CITY OF ALBUQUERQUE

RE: **Lot 15 Block 4 SAD 228**
Volcano Cliffs Subdivision
6423 Canavio St NW
Grading and Drainage Plan
Engineers Stamp Date 4/27/17 (D10D003D15)
Pad Certification Date: 6/26/17

Based upon the information provided in your submittal received 11/17/17, this plan cannot be approved for Certificate of Occupancy until the following comments are addressed.

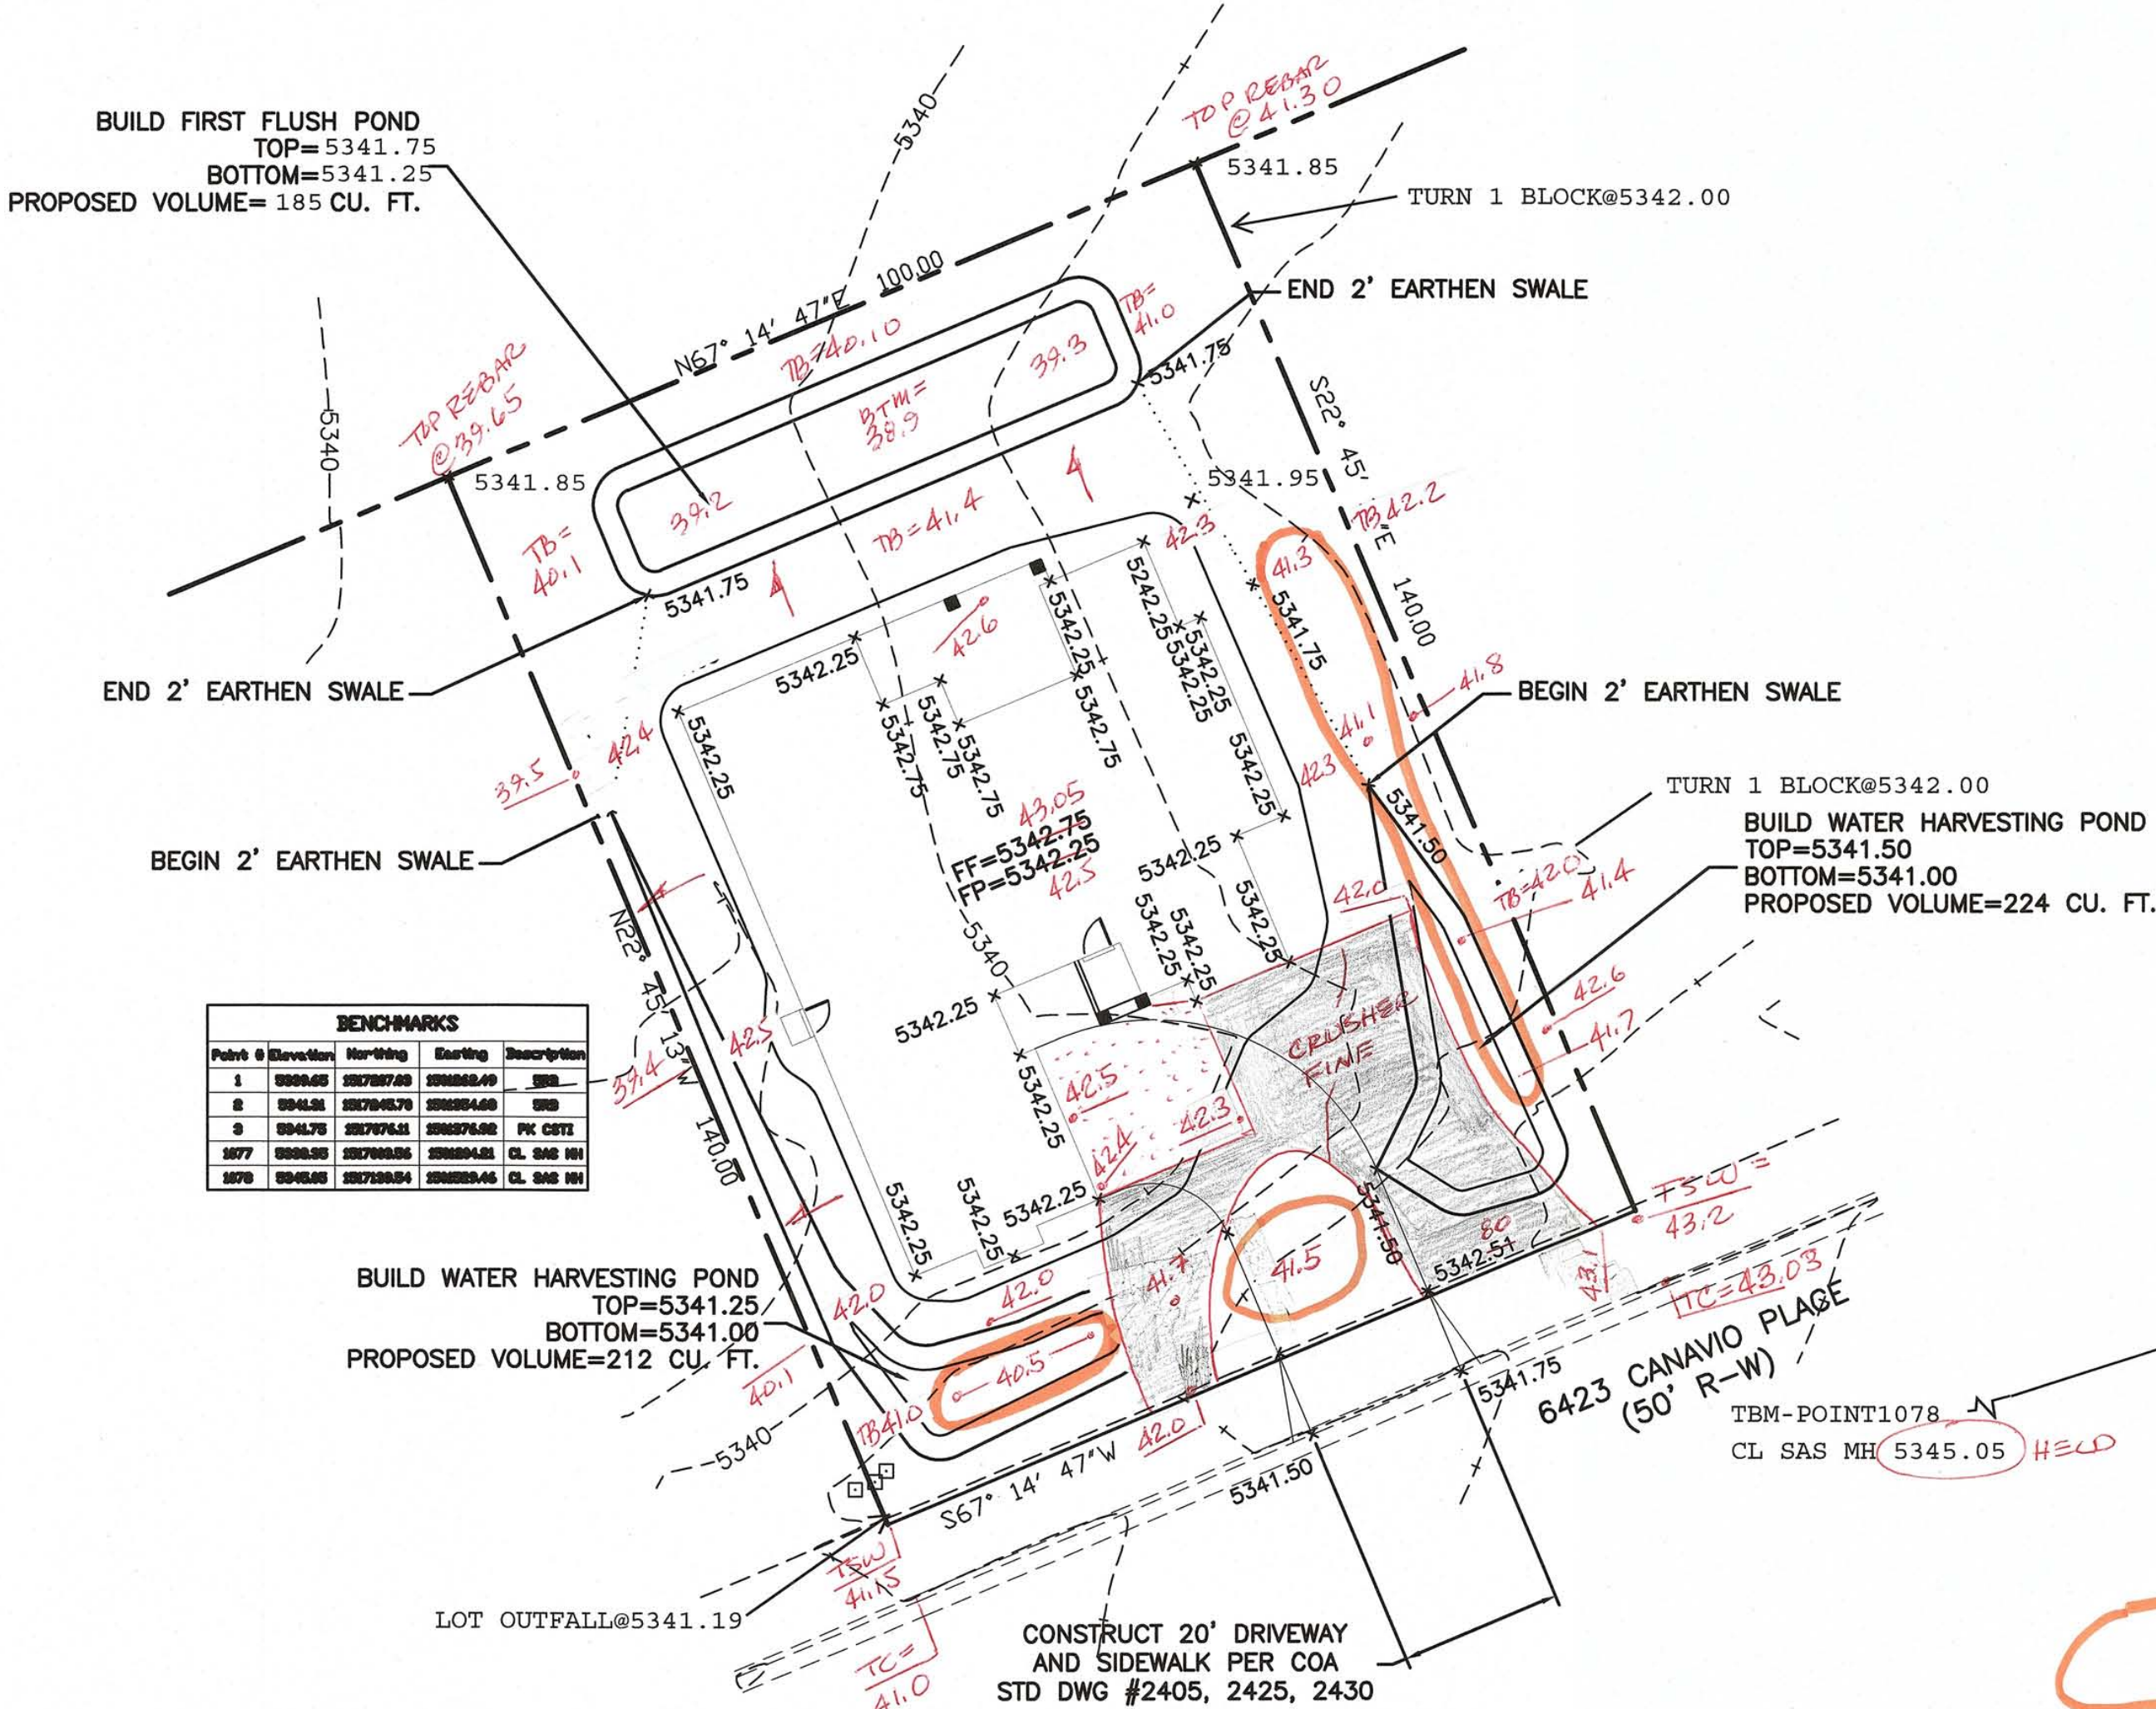
- The swale on the west side of the home is not in place. A retaining wall may need to be installed so a swale can be provided. All flows on this side of the home drain toward the lot to the south.
- A block wall is under construction and the turn blocks were not visible. Is there a permit for this wall? The small block walls coming from the home toward the property lines appear to be obstructing the flows of the swales.
- The pond on the SW corner of the property appears to back flow towards the property to the south, this area needs to be addressed.
